Access Compliance Report Public Rights-of-Way (RR Crossings)

Intersection ID: 10035790	Main Street: REMOUNT_RD	Location: N/A
ADA ID: 459E2689F62A	Overall Compliance: No	Severity Score: 0.0
Codes/Mitigation Info/Possible Solution		Field Measurements/Component Compliance

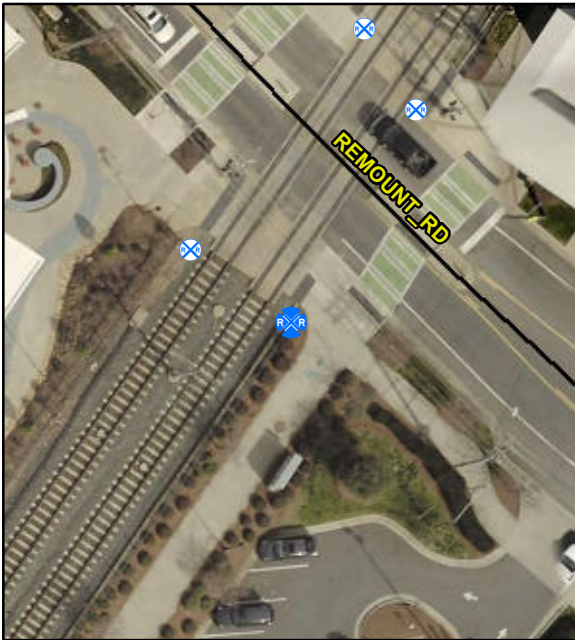
Remove & Replace Detectable Warning System. Provide Pedestrian Gate. Remove & Replace Walking Surface Adjacent to Rail.

R302.7.4, R305.2.5

Compliance	Description	Data
Yes	DWS Provided?	Yes
Yes	DWS Contrast?	Yes
Yes	DWS Width (in)	Yes
Yes	DWS Length (in)	36.0
No	DWS Offset (in)	40.0
No	Pedestrian Gate?	No
N/A	DWS Outside Gate?	N/A
N/A	Rail Type?	LightRail
No	Flangeway Gap (in)	3.0
Yes	Sidewalk Width (in)	96.0
